**CITY OF SHERWOOD
DECEMBER 31, 2025
HEARINGS OFFICER STAFF REPORT**

**GH MCCULLOCH
SITE PLAN REVIEW
LU 2025-008 SP**

PROPOSAL: A request for a Type III – Site Plan Review (SP) for the development of an approximately 15,000 square foot pre-engineered metal building, a fenced material handling yard that will have some distribution and receiving truck traffic. The building program includes approximately 3,000 square feet of office, 3,000 square feet of mezzanine storage, and the remainder of the building is programmed for industrial use.

AKS DRAWING FILE: 8627-06 LANDSCAPING LAYOUTS.L1.0

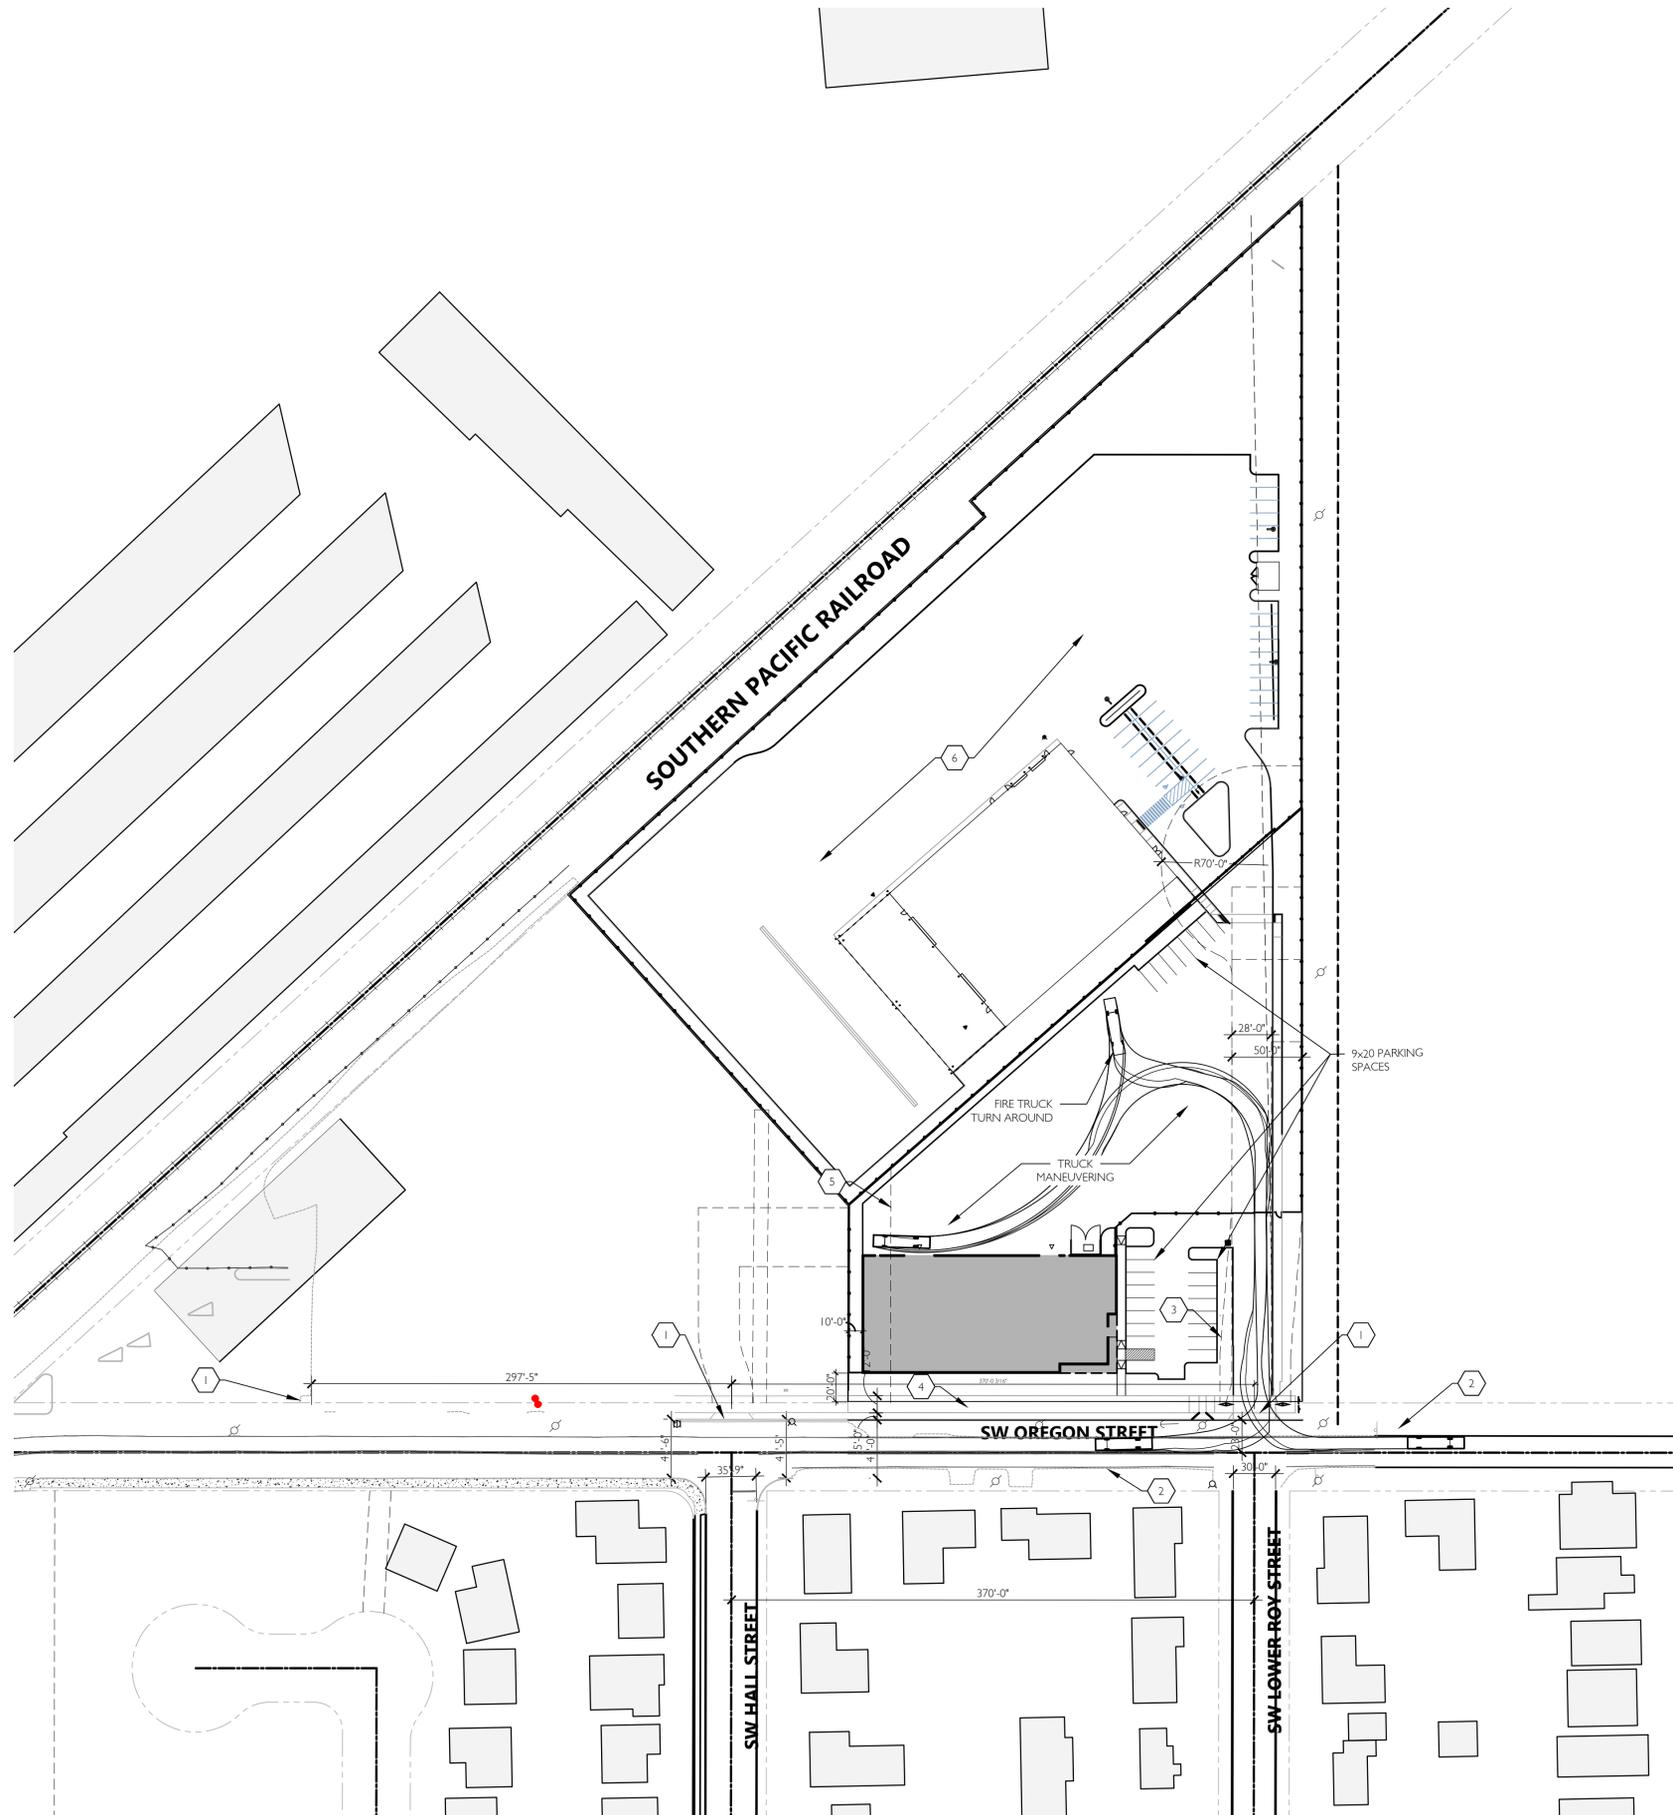
8. Site Area Landscaping:
- a. Required landscaping in the 10' wide perimeter landscaping buffer is now shown and labeled on sheet LI.0.
 - b. Required landscaping in perimeter landscaping buffer reduction area shown and labeled on sheet LI.0.

- c. Parking area landscape areas are called out on sheet LI.0.
 - d. The landscape island immediately east of the trash enclosure is now shown with complete landscaping on sheet LI.0.

1 SITE PLAN
 A0.1 SCALE: 1"= 30'-0"

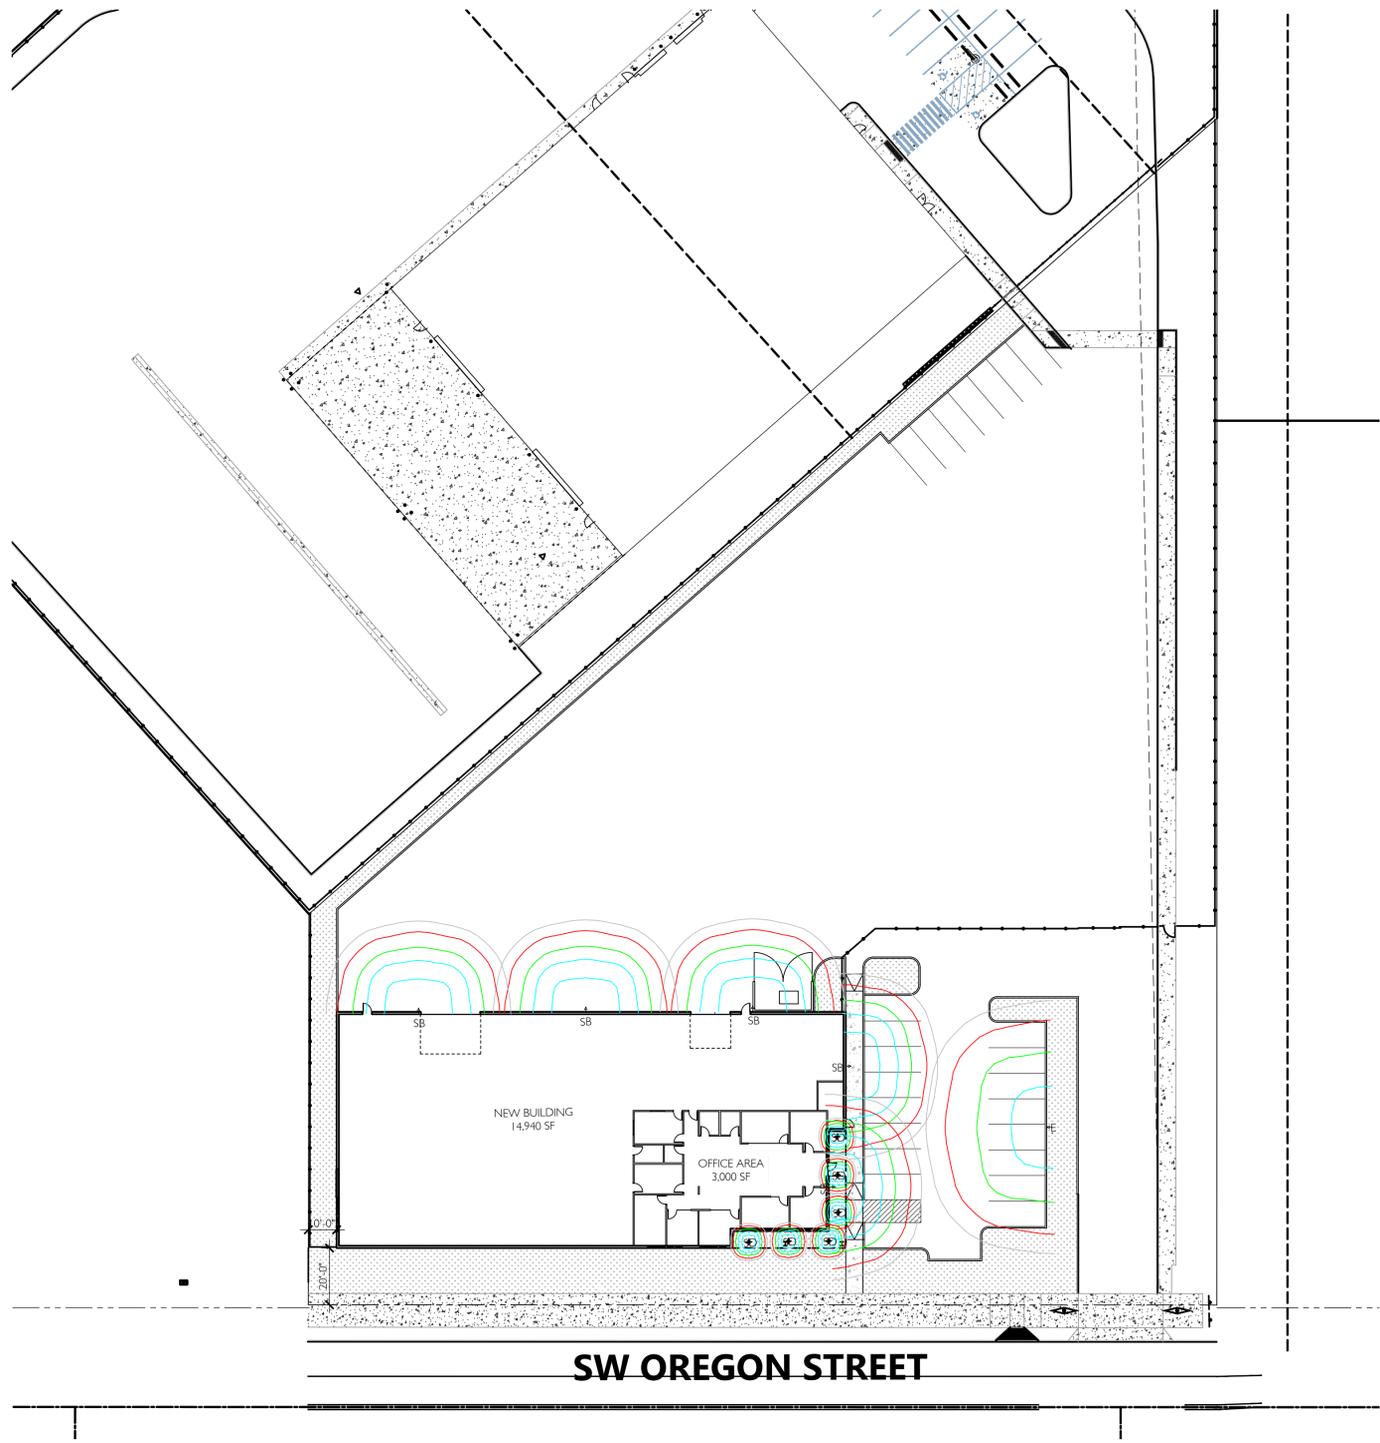
- of cladding materials, the entry area is recessed to create a three-dimensional element.
 - c. The hardscape area north of the building is screened by a fence as indicated by keynote 4 on I/A0.1. The keynote has been updated to clarify that the fence will have black vinyl slats for sight obscurity.
